Craig Lee -Equal Power Panner board

Fixes needed on REV 4.0 board date #121120

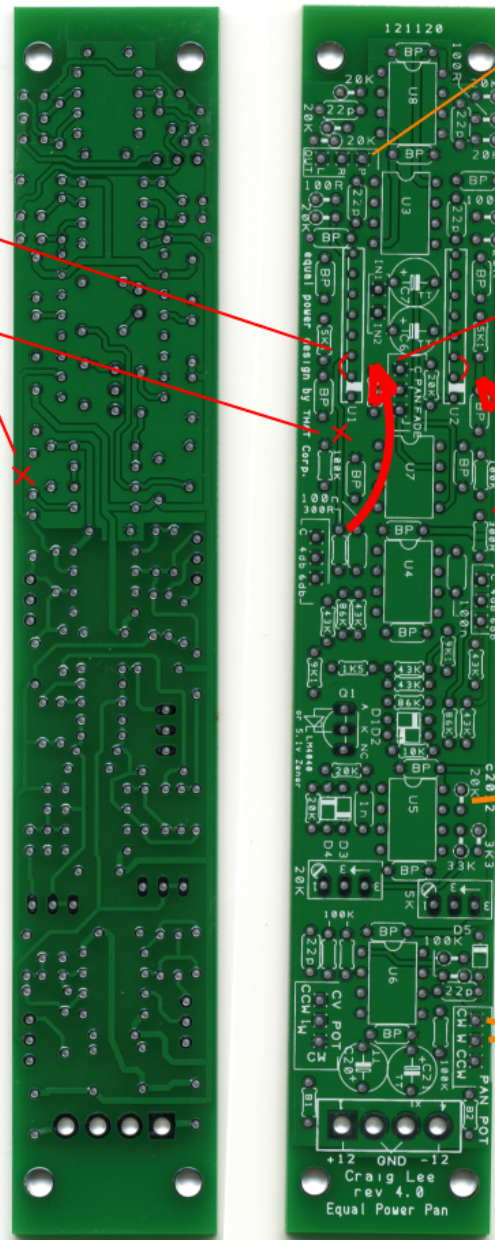
Jumper PINS 2 &3
on both SIPs

CUT these traces

Jumper wire from 300R to
THAT2180 pin

"P" is the
crossfade out

Jumper from 300R
to PIN 2 of the 2180

Jumper from 300R
to PIN 3 of the 2180

(the 2180 pin soldered
should not be attached
to the board or socket)

22K
(not 20K)

These are reversed
(connect wiper to "CW")

INPUT 2 is the main input (the one connected when using as a panner)

Install all resistors and diodes standing up.

PLEASE REMEMBER - the orientation of the THAT2180s is REVERSED from the op amps. PIN1 down where the op amps are PIN1 up (this allows a short trace from the output to the op amp)
